APPENDIX 3 - FOR DECISION EDENBRIDGE - HIGH STREET - PARKING PROPOSAL

Description and plan of parking proposals, objection received and Officers' comments/recommendation

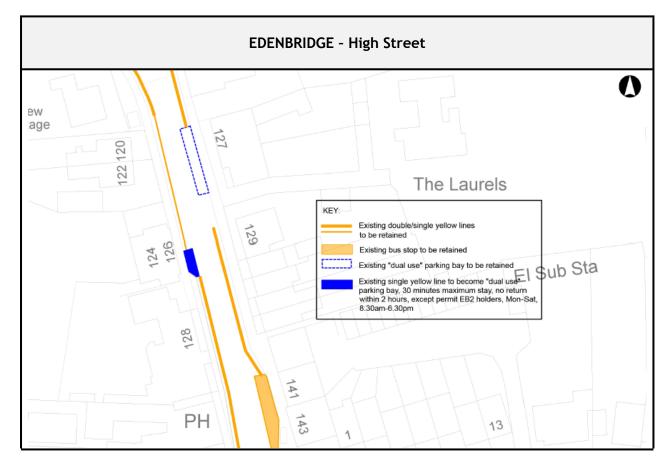
Description	Proposed Changes
West side, outside nos. 124/126 High Street	Replace short section of single yellow line (no waiting, 8.30am - 6.30pm) restrictions with "dual use" parking bay (Monday to Saturday, 8.30am - 6.30pm, 30 minutes maximum stay, no return within 2 hours, except permit "EB2" holders)

(Edenbridge Town Council) Members don't support this application as the road configuration already causes difficulties for traffic flow - many near-misses have been observed.

This parking proposal is in response to concerns raised about the lack of on-street parking space availability during the day for residents of the section of High Street concerned.

The configuration of the road limits the locations in which additional on-street parking spaces could be provided, and therefore the proposal is to create a dual use parking bay for one vehicle at the southern end of the recessed area on the west side of High Street outside nos. 124/126, where the road is wider.

A single yellow line parking restriction, preventing parking during the day, currently controls much of this section, including the recessed area, and hence parking can already take place in this location overnight.

It is recommended that the objection be set aside, and the proposal be implemented, as drawn.
